Project No. R.0171363.001

Addendum #002

Tender A – Pleasant Camp Port of Entry

2015-04-17

1 M101 SITE SERVICES BUILDING PLUMBING & FIRE PROTECTION PLAN
SCALE: 1:50

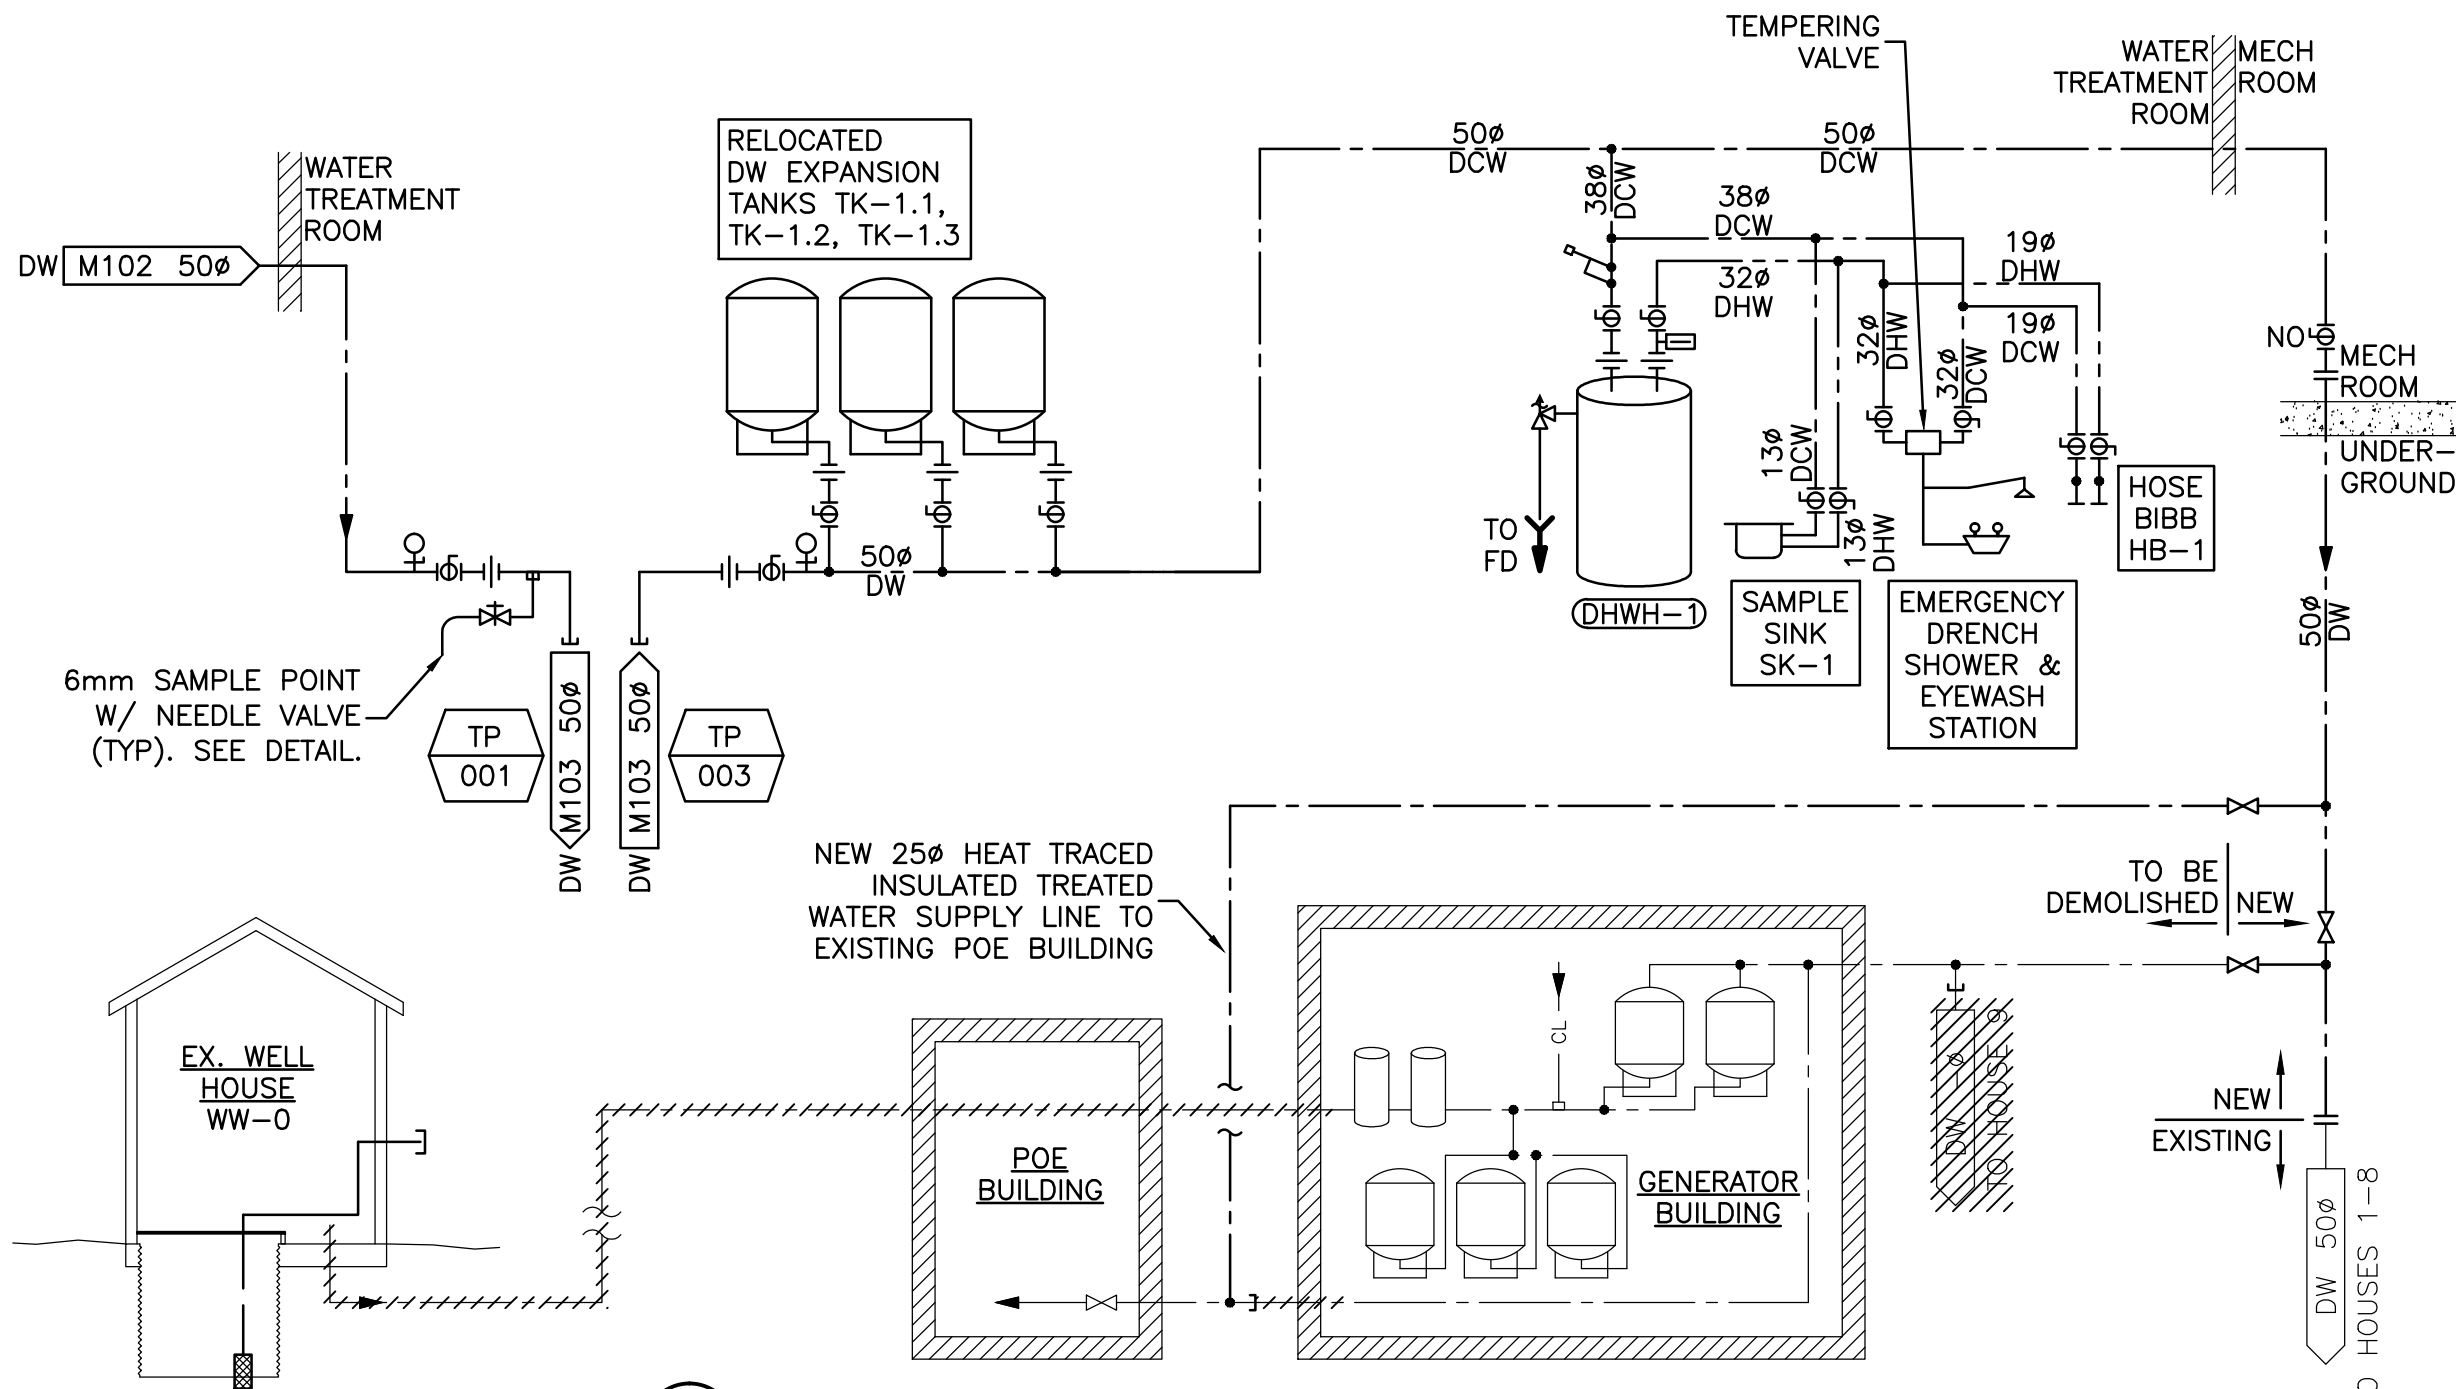
1. Drawing M101, plan 1: Revise layout to accommodate RO treatment system skid and new tank TK-1.4 as shown on attached sketch SKM-001 including:
 - a. Delete TK-1.4 and replace with new treated water storage tank TK-1.4 bolted to the floor

- b. Provide new RO Water Treatment Skid per specifications included herein
 - c. Delete TK-1.5 and TK-1.6 installation, turn over to owner instead. Delete associated housekeeping pad.

- d. Delete new 1 and 10 micron filters.
 - e. Replace TK-1.7 and CL-1 and CL-2 with chlorine tank and pumps included as part of the water treatment package per specifications.

- f. Relocate TK-1.1, 1.2, 1.3 to and provide associated housekeeping pad.
 - g. Relocate emergency shower and associated floor drain to chlorine room and leave wall clear for electrical panel (South side of East-West wall dividing Water Treatment Room and Chlorine Room)

- h. Relocate hose bib to sink side of wall and leave wall clear for electrical panel (South side of East-West wall dividing Water Treatment Room and Chlorine Room)

- i. Revise floor drain adjacent to RO Water Treatment Skid to FD-2 and coordinate location with Skid.
 2. Drawing M102, schematic 6: Revise per attached sketch SKM-002.

KEYNOTES
① COORDINATE LOCATION OF FLOOR DRAIN WITH RO SKID.

6 WATER SERVICE SCHEMATIC – REVISED
M102 SCALE: NTS

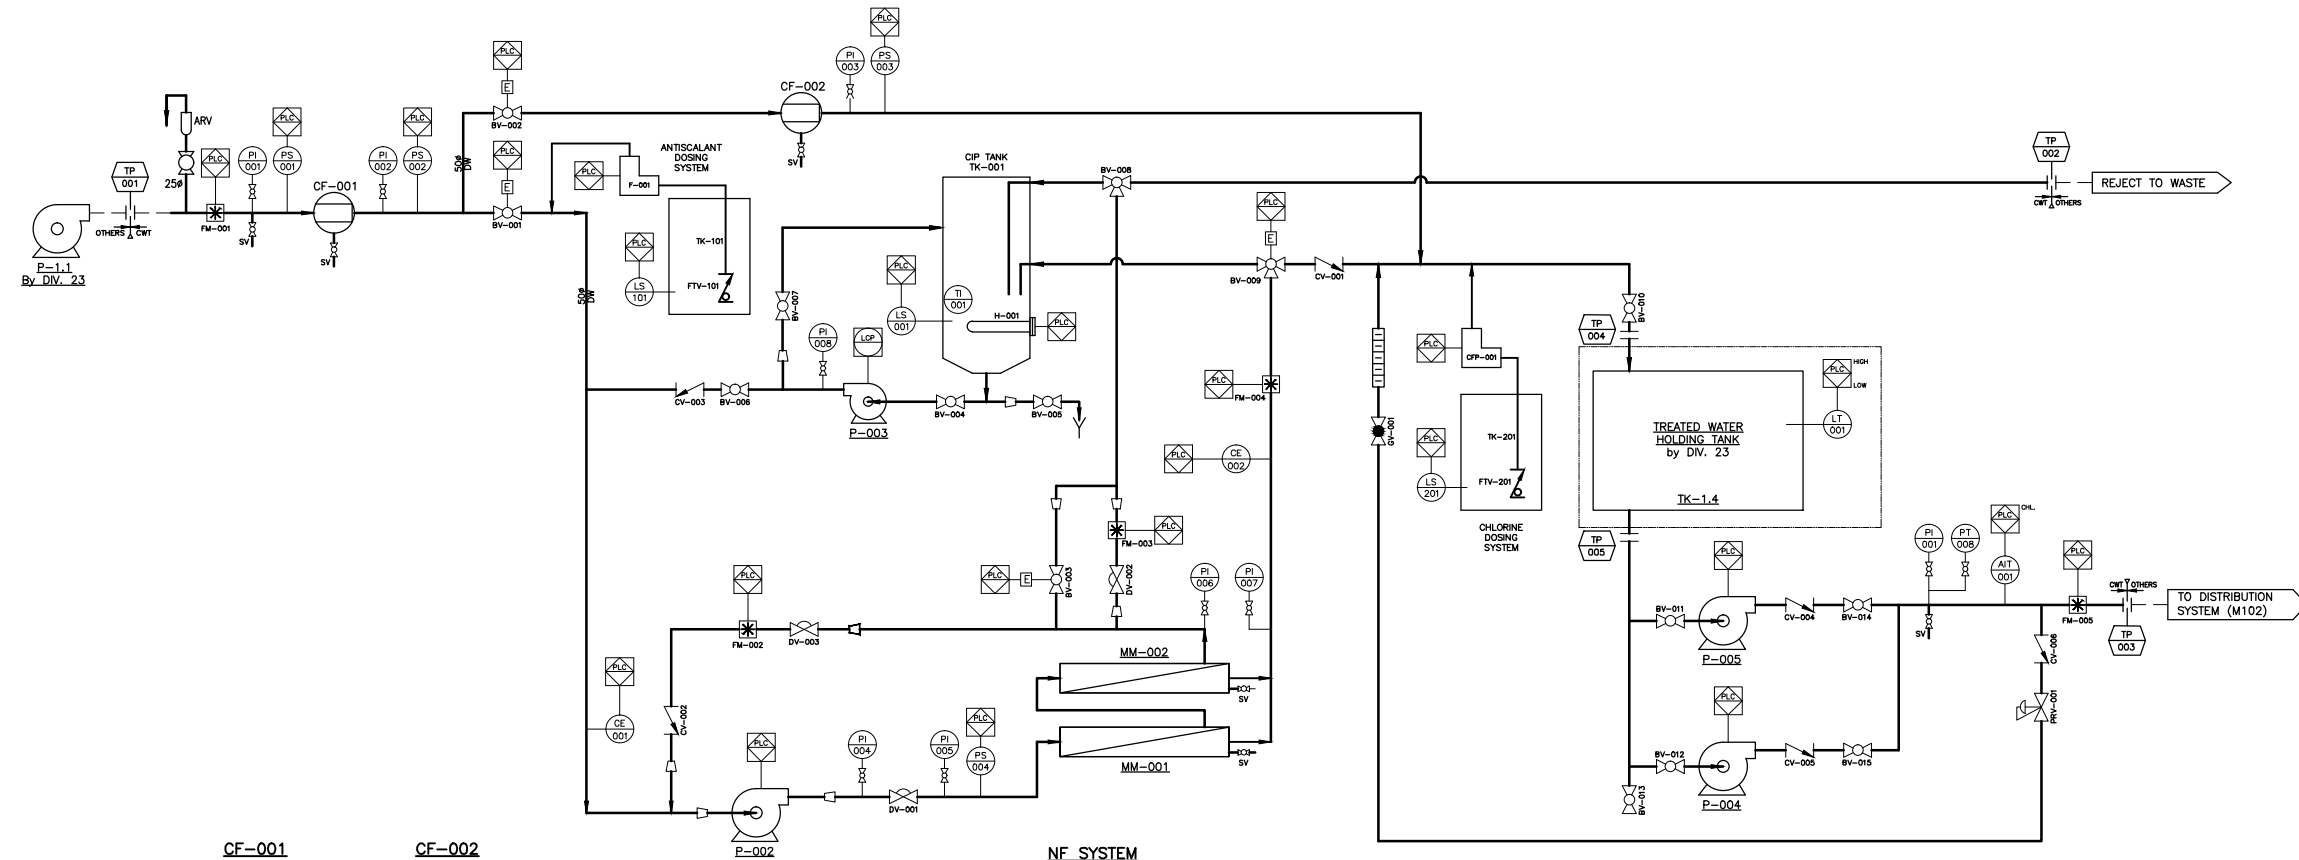
3. Drawing M102, schematic 6: Revise per attached sketch SKM-002.
 4. Drawing M701, Plumbing Fixtures Schedule:
 - a. Add FD-2; Description = Funnel Floor Drain, San diameter = 100mm.
-
